FortisBC Energy Inc.

Application for a Certificate of Public Convenience and Necessity  
for the Advanced Metering Infrastructure Project

Decision  
and Order C-2-23

May 15, 2023

Figure 1. Spectral radiance associated with Blackbody Radiation.  
Source: [https://commons.wikimedia.org/wiki/File:Black\\_body.svg](https://commons.wikimedia.org/wiki/File:Black_body.svg)

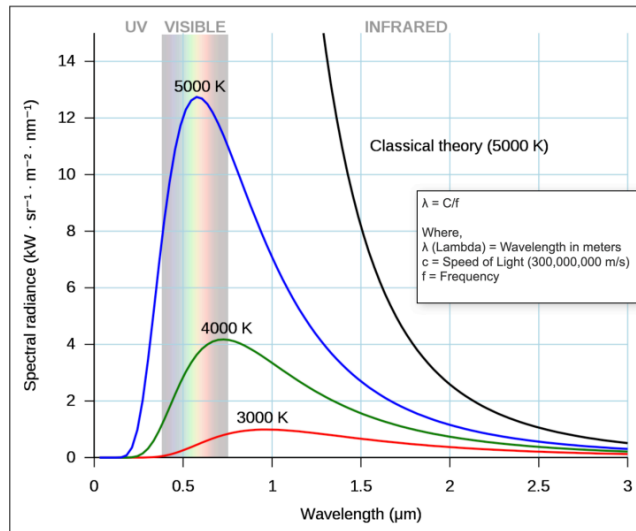
It is possible to convert frequency to wavelength and vice versa with the equation shown in Figure 1. Using this equation, the frequency of 3 μm wavelength is 100,000 GHz. Since RFR [radiofrequency radiation] only goes up to 300 GHz, this is definitely NOT RFR. [emphasis in original] Similarly, 300 GHz frequency has a wavelength of 1 mm, which is 1,000 μm and this is larger than the 3 μm in the figure above.

Exponent submits that Dr. Havas does not acknowledge that the wavelengths of the electromagnetic fields in the Figure 1 cited from Wikipedia only extend to 3 micrometres ( $\mu\text{m}$ ). In other words, the lowest frequency shown is about 100,000GHz. Exponent states the wavelengths cited by Exponent for the earth and human body extend far off the graph as their frequencies are much lower, in the order of 3kHz to 300GHz. As a comparison, Exponent submits the following Figure, from a peer-reviewed engineering journal, which shows the power density of blackbody radiation from a human body, although less than a light bulb, is evident. Exponent states the energy from a human or earth is so small as to be negligible to any potential exposure assessment.<sup>615</sup>

Figure 5. RF exposure of a Sonix IQ gas meter relative to other RF sources.

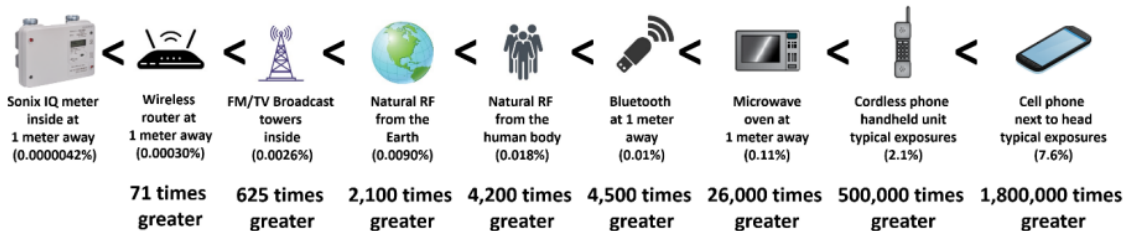
Dr. Havas states that the various devices provided in Figure 5 emit at different frequencies, which were not provided and on which the Safety Code 6 guidelines are frequency dependent, so comparing them is like "comparing apples and oranges." Dr. Havas provides alternative calculations related to power density of various devices to check the accuracy of the information provided in Figure 5 of the Exponent RF Technology Report.<sup>620</sup> Dr. Havas' calculations are provided in Table 1 of her expert report, reproduced below.<sup>621</sup>

CORE submits Dr. Havas’ report shows inconsistencies in the calculations in the Exponent RF Technology Report, specifically those shown in Figure 5. CORE urges the BCUC to carefully review the findings of Dr. Havas. CORE submits the inconsistent values and power density for each of the objects in Figure 5 cannot be viewed as “internally reliable” and therefore the BCUC should exercise caution in assigning weight to Figure 5.<sup>624</sup>

In response to Dr. Havas' criticism of Figure 5 of the Exponent RF Technology Report, FEI reiterates that Exponent did, in fact, provide the frequencies and power density of the radiofrequency sources, and Exponent has pointed out multiple errors in Dr. Havas' calculations in rebuttal evidence, which CORE failed to acknowledge.<sup>625</sup>
